STAFF RECOMMENDATION
128 Second Avenue North
February 20, 2019

Application: Rehabilitation: Window Replacement
District: Second Avenue Historic Preservation Zoning Overlay
Council District: 19
Map and Parcel Number: 09306207900
Applicant: Mark Bixler, Manuel Zeitlin Architects, LLC
Project Lead: Robin Zeigler, robin.ziegler@nashville.gov

<p>Description of Project: The applicant proposes to replace the non-historic windows on the top floor of the First Avenue side of 128 2nd Avenue North with roll-up doors, pushed back from the existing wall plane.</p> <p>Recommendation Summary: Staff recommends disapproval finding that the proposal does not meet sections H.3-5 and 9 of the Second Avenue design guidelines for replacement windows, sections I.1 and 2 for wall alterations and section J for replacement materials.</p>	<p>Attachments A: Elevations</p>
--	--

② 1st Ave El evation - proposed
1/8" = 1'-0"

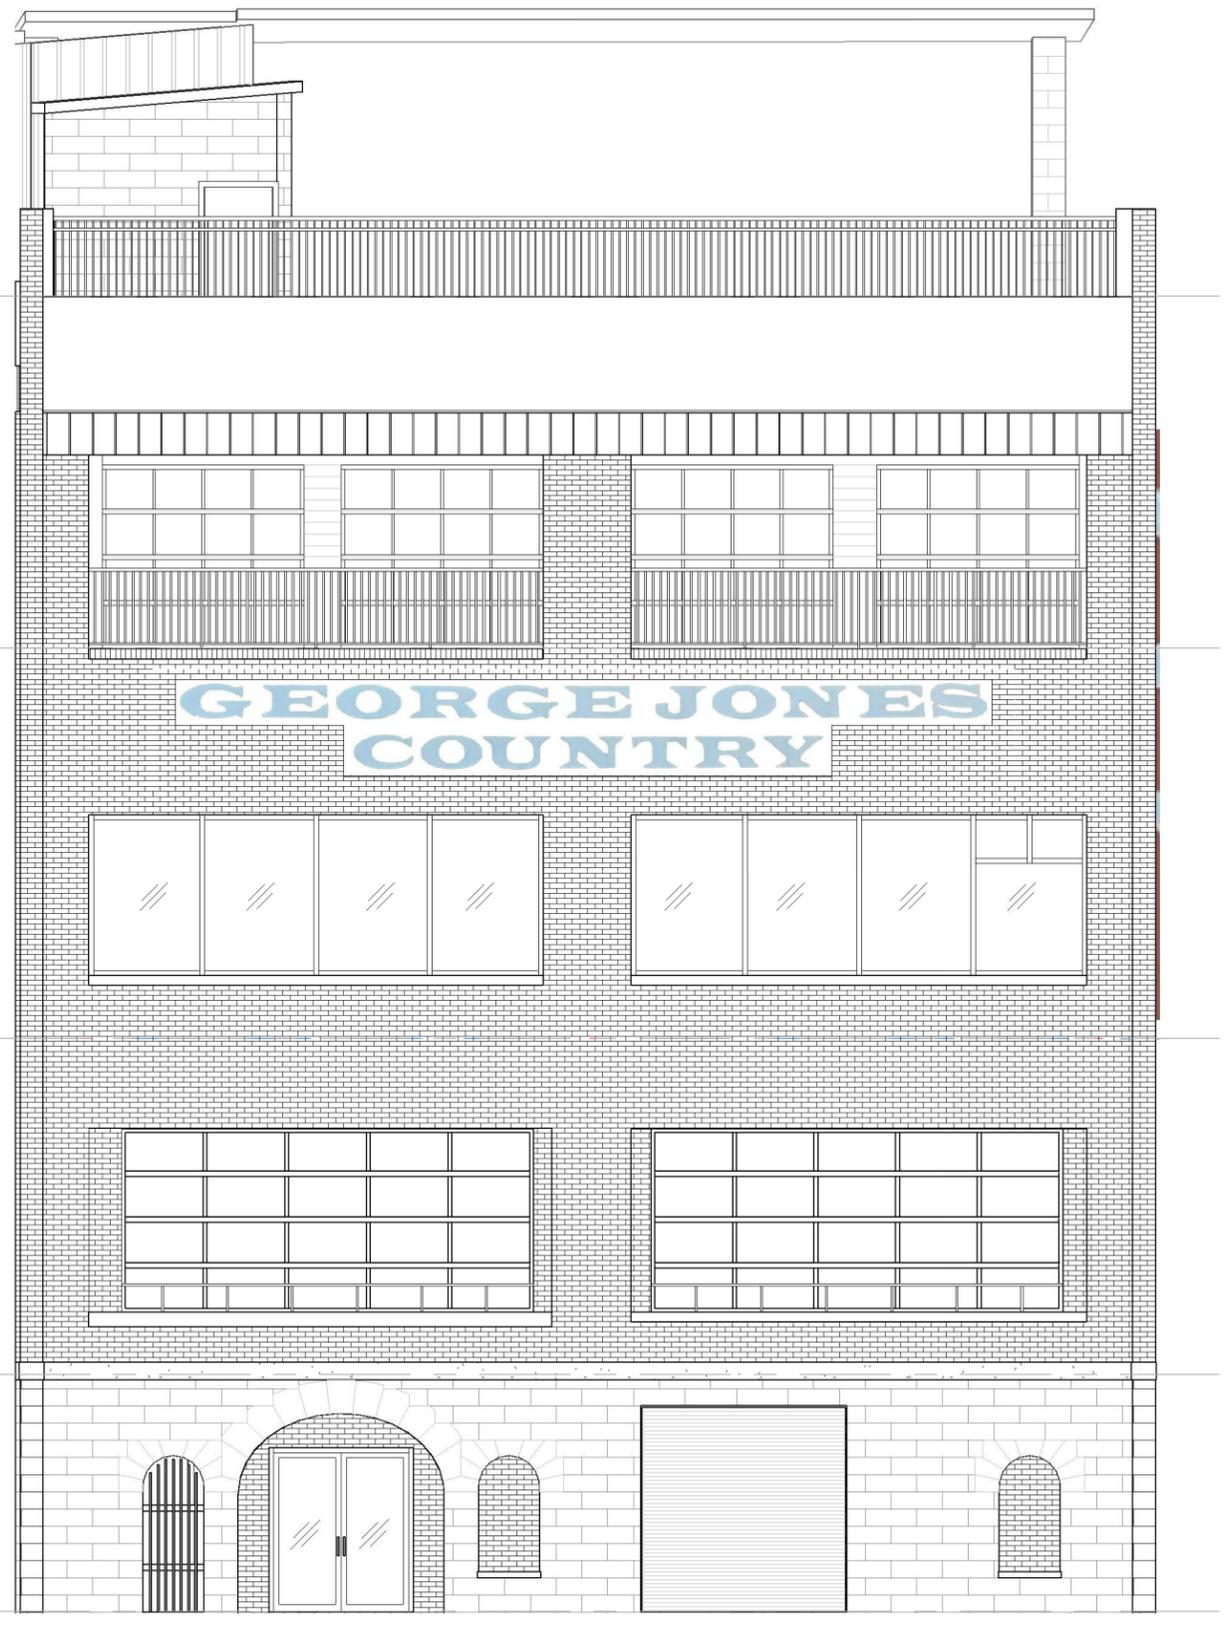
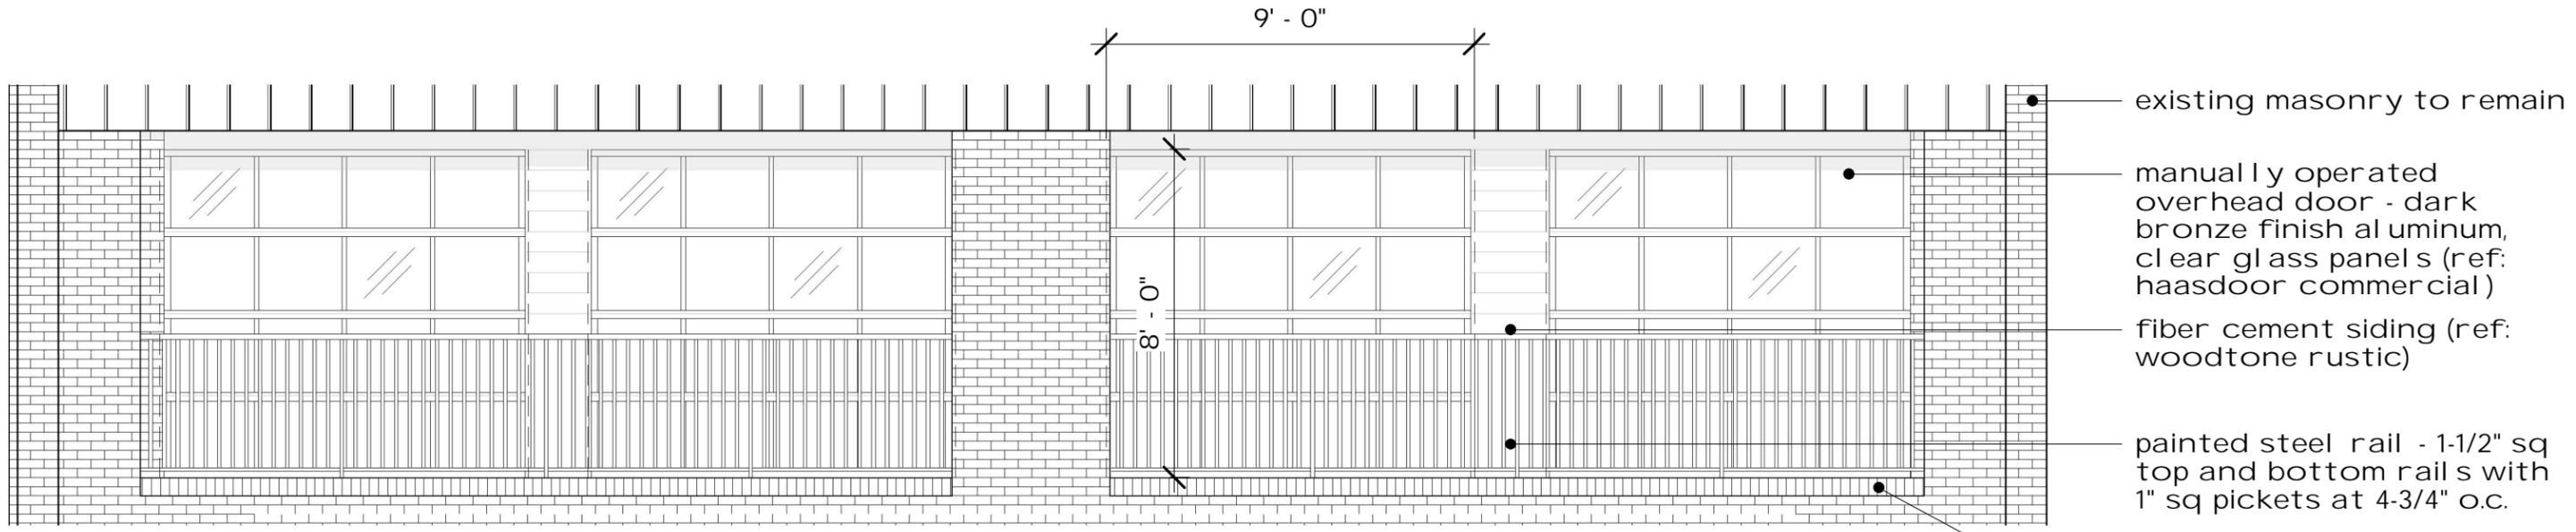
The project does not meet section H.3-6 for the design and configuration of the proposed replacement windows. The proposed windows do not replicate original windows or a style that is appropriate to the historic building’s style and period. A photograph, from the early 1900s (see Figure 2) shows that the building had industrial steel windows.

The project does not meet section 5, which states that steel windows should be replaced with steel or aluminum window designs that replicate the appearance of the original windows. Typically, these industrial windows were fixed windows with a central light or collection of about four lights creating a larger square that was operable as a hopper or awning type of window. A roll-up window or door would mean that the entirety of the opening would be open rather than just a

central portion and no part of the window would remain visible. With historic windows, because the design was a hopper or awning type, the open portion of the window remained fully visible when open. (See Figure 3.) In addition, the proposal locates the windows three feet (3') back from the exterior wall with a partial covering of a railing, both design features that do not mimic historic conditions.

The project does not meet section H.9 which states that window grilles and balcony rails are not appropriate window treatments. A balcony type of railing is proposed for this project.

Pushing back the windows three feet (3') from the exterior of the historic wall does not meet section I for walls as it does not retain the original plane and creates a recess where one did not exist historically. Section I.1. requires that original walls, including plane and openings should be retained. Pushing back the windows and adding the railings creates a balcony which does not meet section I.2. of the design guidelines which states that balconies should not be added to public facades.

Materials include a painted steel rail, dark bronze aluminum windows with clear glass and fiber-cement siding between each pair of proposed doors. Aluminum is listed as an appropriate material for replacement steel windows; however, fiber-cement siding is not an appropriate wall replacement material. Historically, it appears that the steel windows of the top floor were continuous and did not have areas of wall between them. (The entirety of the wall cannot be seen in the historic photo.) Staff finds that introducing this section of wall is inappropriate as it will effectively change the dimension of the windows within the historic masonry openings. The project does not meet section J for materials.

Staff recommends disapproval finding that the proposal does not meet sections H.3-5 and 9 of the Second Avenue design guidelines for replacement windows, sections I.1 and 2 for wall alterations and section J for replacement materials.
